Walton-on-Trent Bypass

Proposed Scheme and Road Stopping Up Access/Restricted Access - Figure 4.4

Status		Status Date
Draft		Mar 2024
Drawn	Checked	Date
CDW	MT	06.03.2024
Scale	Number	Rev
1:2500	10738-100-015	A
0 50 100 150 200 250		
METRES

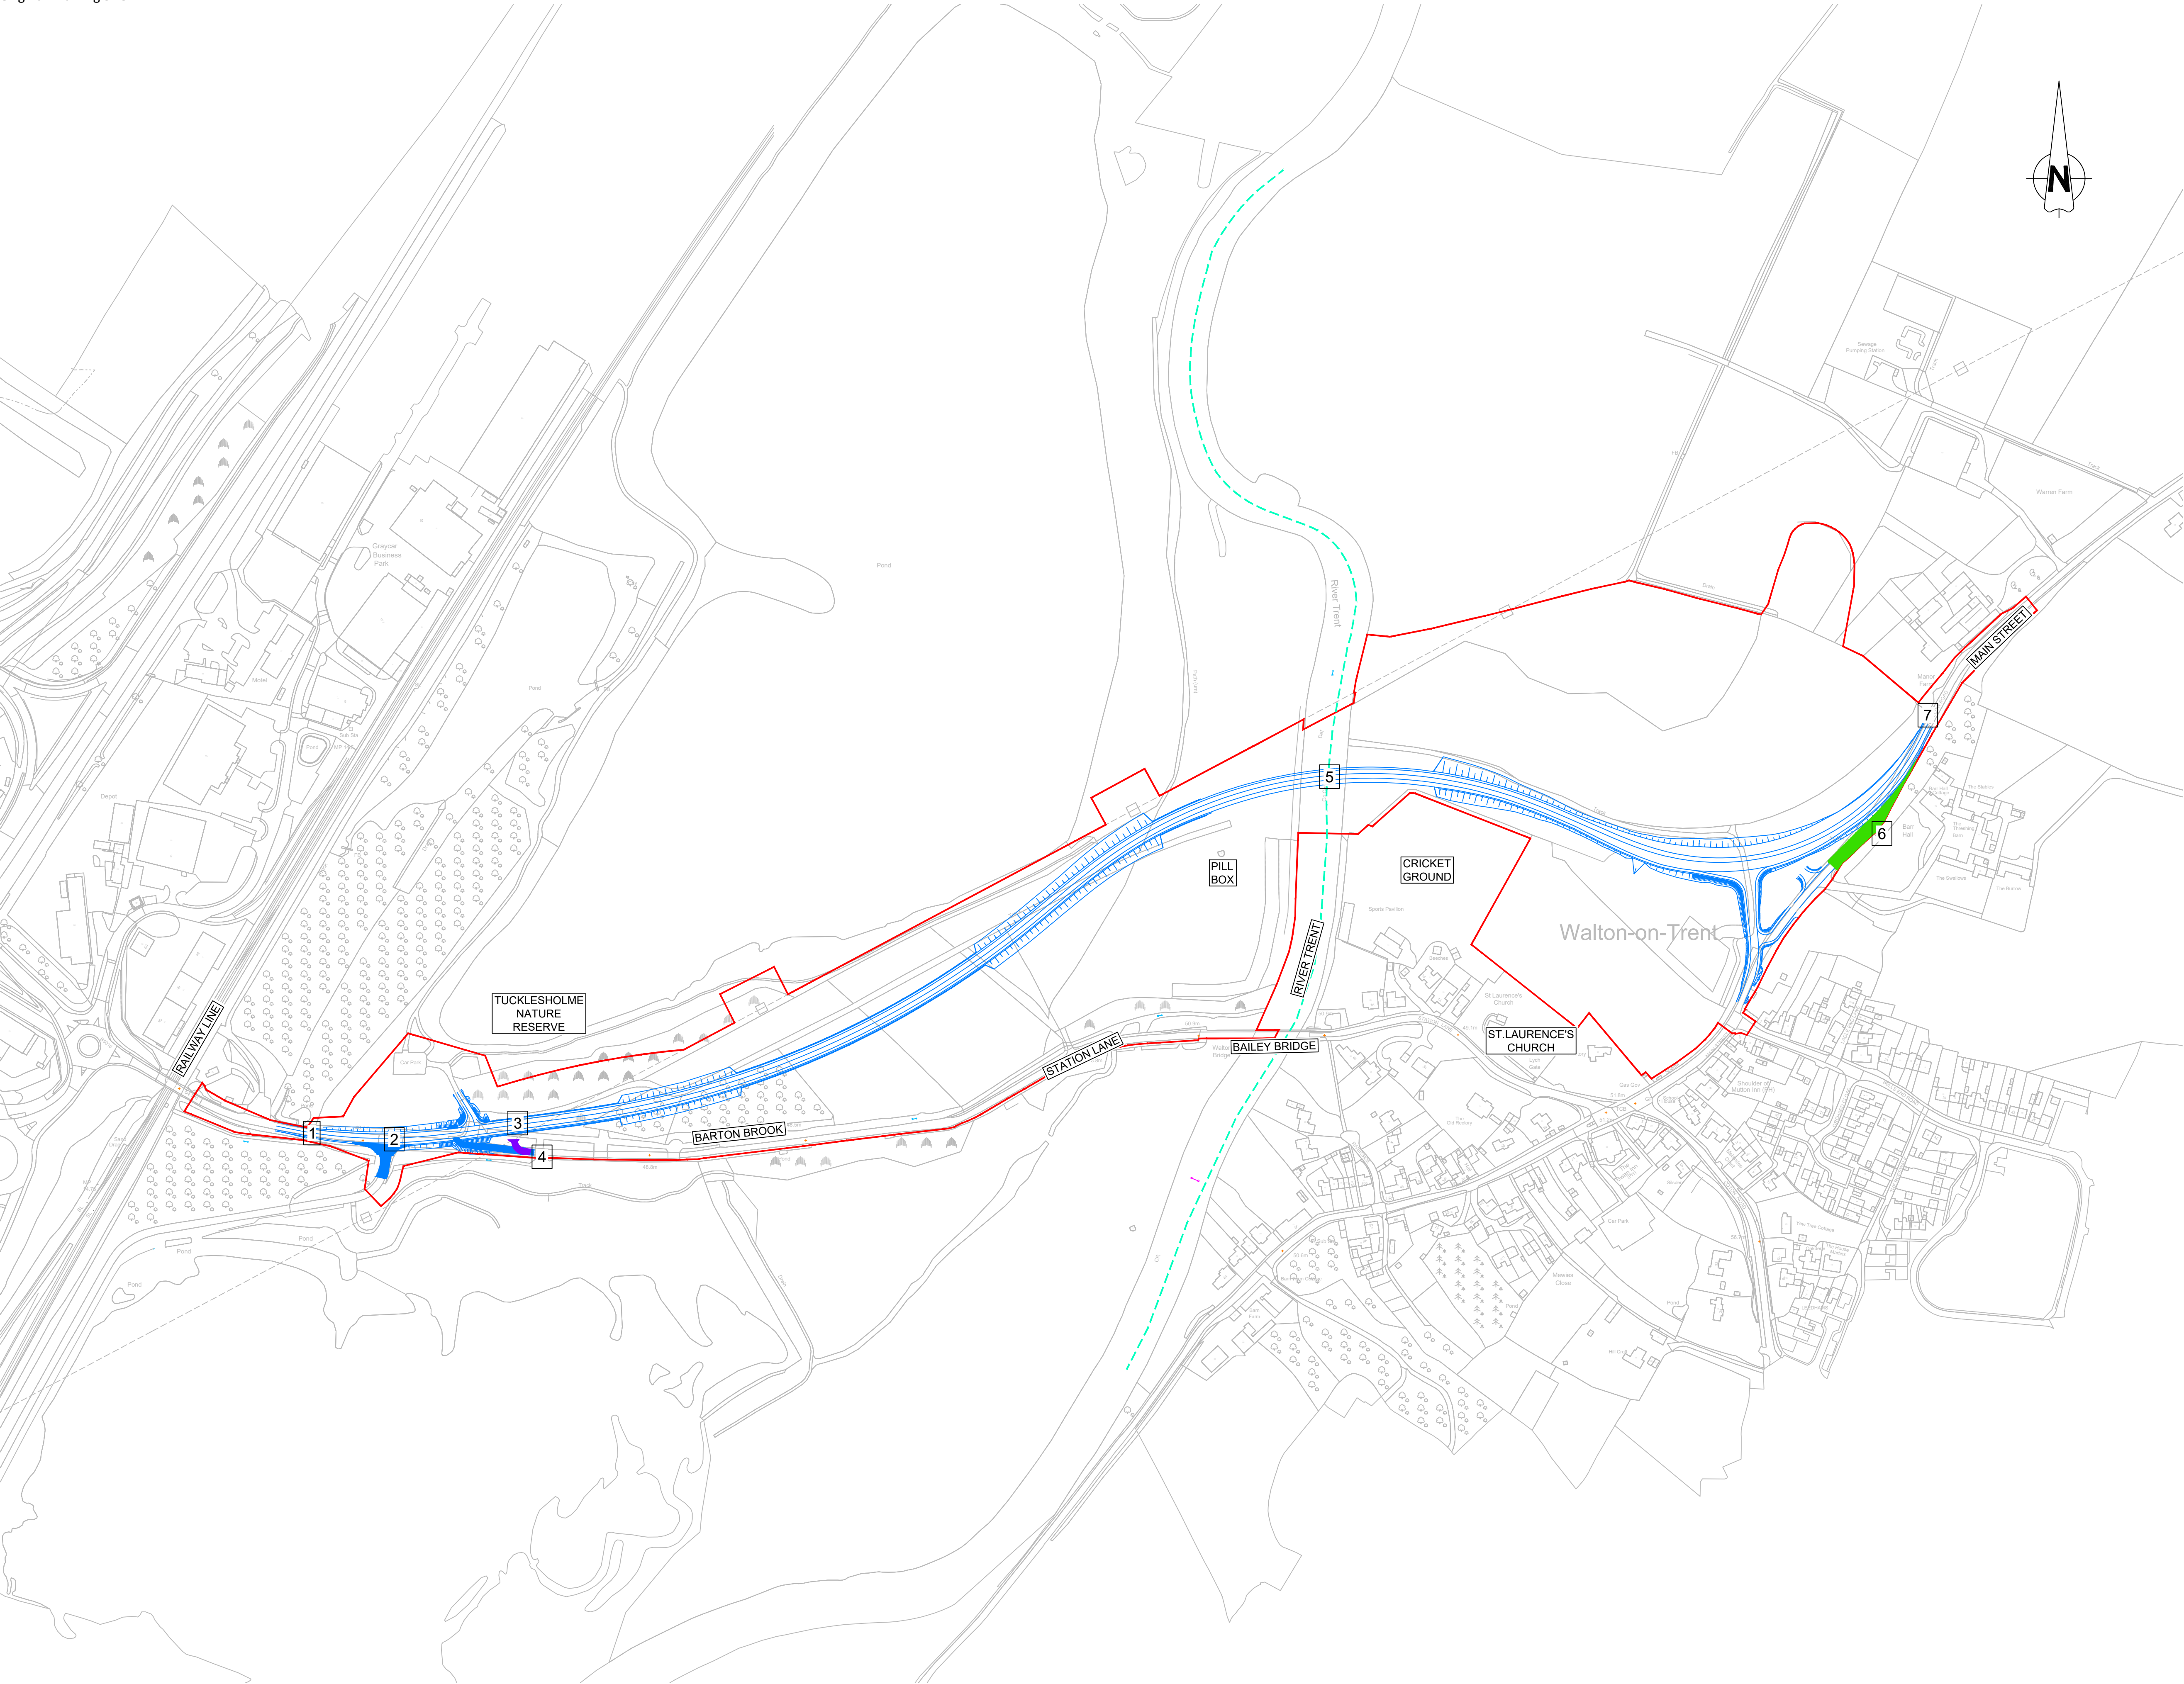
- Alignment changed and tie-in to existing highway moved west, to raise the bypass above flood levels for entire length
- Additional tie-in to quarry now required due to increased height of bypass
- Works required to Barton Brook due to change in alignment to raise the level of the bypass above flood levels, and meet Staffordshire County Council Technical Approval
- Proposed gated access to Station Lane, with vehicular traffic restricted except for essential access.
- Height of bridge increased with earthworks adjusted on the approaches
- Section of existing Main Street to be stopped up. Topsoil and grass seed treatment with fence line amendments subject to detailed design and technical approval.
- Alignment changed at tie-in due to a change in land ownership
